Economic Commission for Europe**Inland Transport Committee****World Forum for Harmonization of Vehicle Regulations****Working Party on Lighting and Light-Signalling****Seventy-second session**

1958 Agreement - Regulations**Other business – Any other business****Proposal for a Supplement to the 01 series of amendments to Regulation No. 123 (Adaptive front lighting systems (AFS))****Submitted by the expert from France***

Figure 1. Light distribution

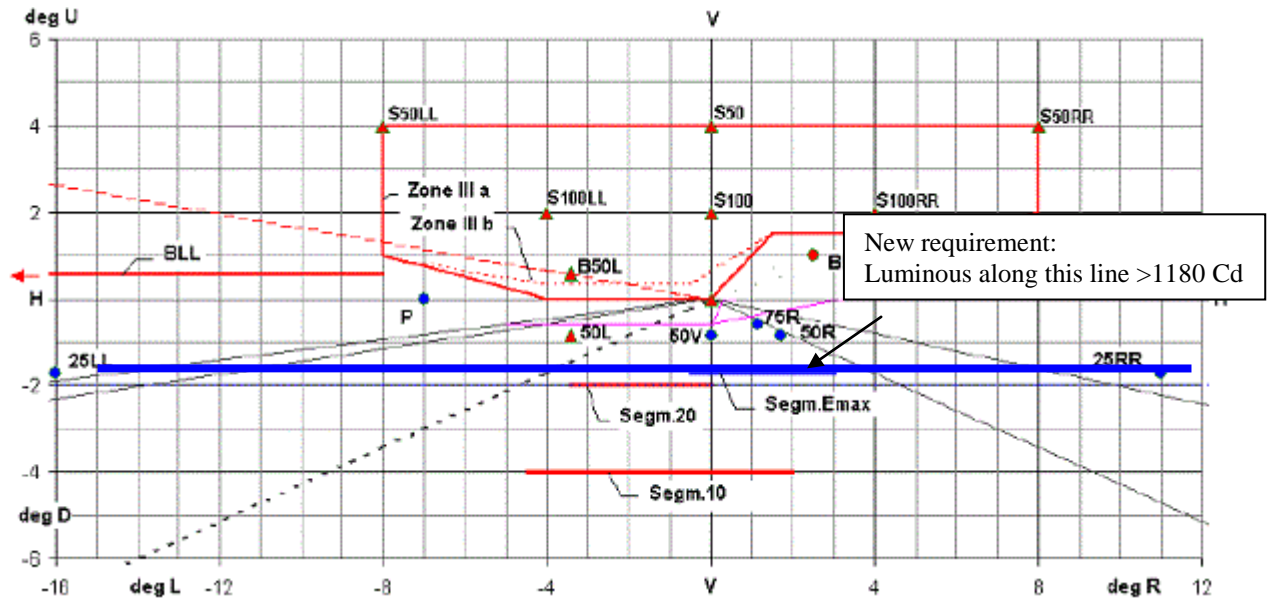
4. Furthermore, as LEDs are more reliable than filament light sources, there will be fewer “blind in one eye” vehicles on the roads.
5. During examination of informal document GRE-71-10, some experts mentioned that the reduction of flux of the LED light source may have an influence on the light distribution of the beam pattern. Such concern may also be applicable to other types of light sources. Consequently, the proposal was amended so as to check that the illumination along the line 25LL -25RR is above a lower limit.

"6.2.9. When the system is at its neutral state, along the horizontal line between 25LL and 25RR, the luminous intensity shall not be less than 1180 Cd;

Figure 2. Luminous flux in the field: 265 Lm.

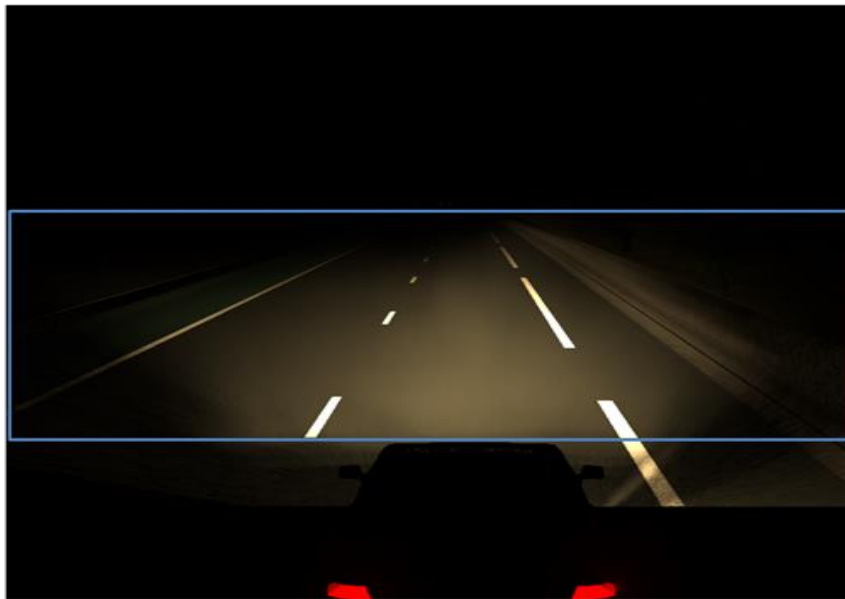
6. Additionally, to ensure a safe luminous output, we add a new request for the luminous flux of the headlamp in the forward field, so that the optical performances are at least at the level of a standard H4 low beam (see picture below).

The luminous flux in the rectangular forward field: horizontally (30°L 30°R) – vertically (10°D - 0°) shall be not less than 250 Lm."
